REFERENCE: J-19/D64 BRIGHT BEGINNINGS DRAINAGE PLAN
COMMENTS DATED 3/21/95

SUBJECT: Bright Beginings on Connstitution NE

RE: GRADING & DRAINAGE PLAN FOR BRIGHT BEGINNINGS (J-19/D64)
RECEIVED MARCH 3, 1995 FOR BUILDING PERMIT APPROVAL
ENGINEER'S STAMP 2/23/95

FIGURE 44

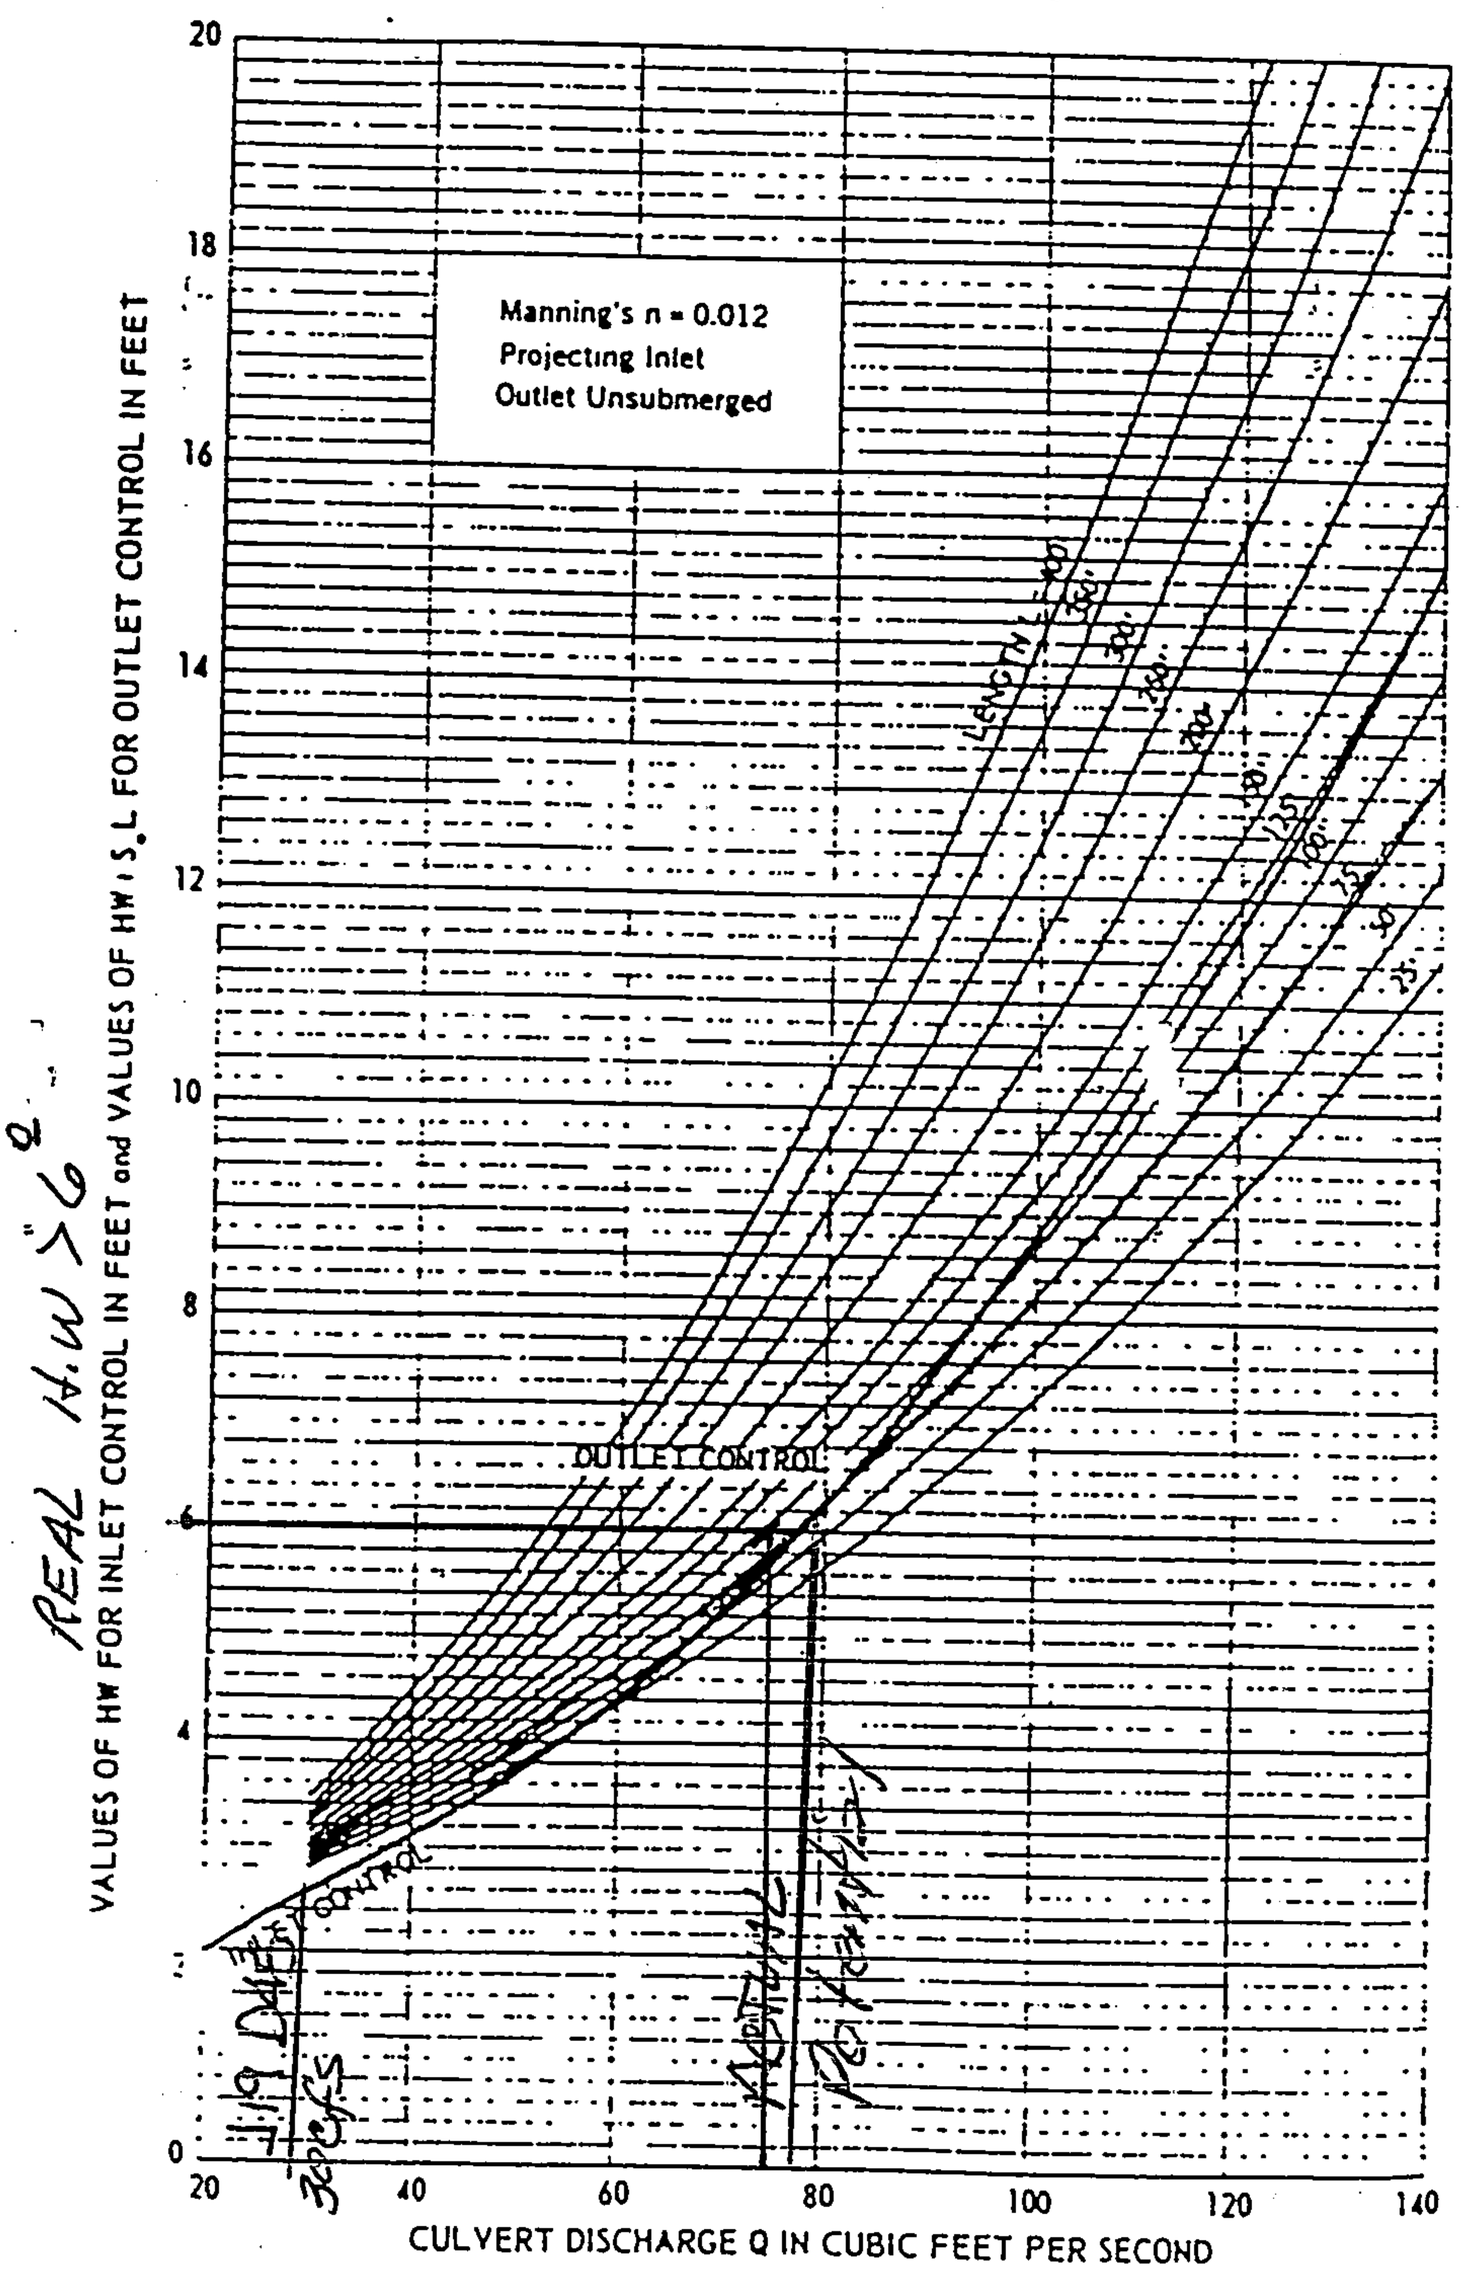
Provide backup information to verify the capacity of the 36" culvert. Identify the drainage basin that flows to the 36" culvert. Compare the capacity of the 36" culvert to the runoff from the developed basin.

1. THE CAPACITY OF THE 36" CULVERT WAS ESTABLISHED AS 30 CFS FROM THE PREVIOUSLY APPROVED DRAINAGE PLAN J-19/D45. FIGURE 44 FROM THE CONCRETE PIPE MANUAL CLEARLY DEMONSTRATES THIS CAPACITY. USING THE TOPOGRAPHY, THERE IS AT LEAST 6 FEET OF HEADWATER POTENTIAL THAT COULD INCREASE THE CAPACITY. HOWEVER, THERE COULD NEVER BE FLOWS OF THIS MAGNITUDE GENERATED UNDER CURRENT STANDARDS. THE PREVIOUS REPORT ALSO INDICATES THAT DURING TESTING OF THE WELL FLOWS GENERATED OF 13.4 CFS WOULD NOT SUBMERGE THE INLET.

Both culverts appear to have capacities substantially greater than the well discharge flows. Figure 44 from the Concrete Pipe Design Manual (attached hereto) suggests that the inlet will not be submerged during well testing and development when flows of 13.4 cfs will be experienced.

REAL H.W. > 6'
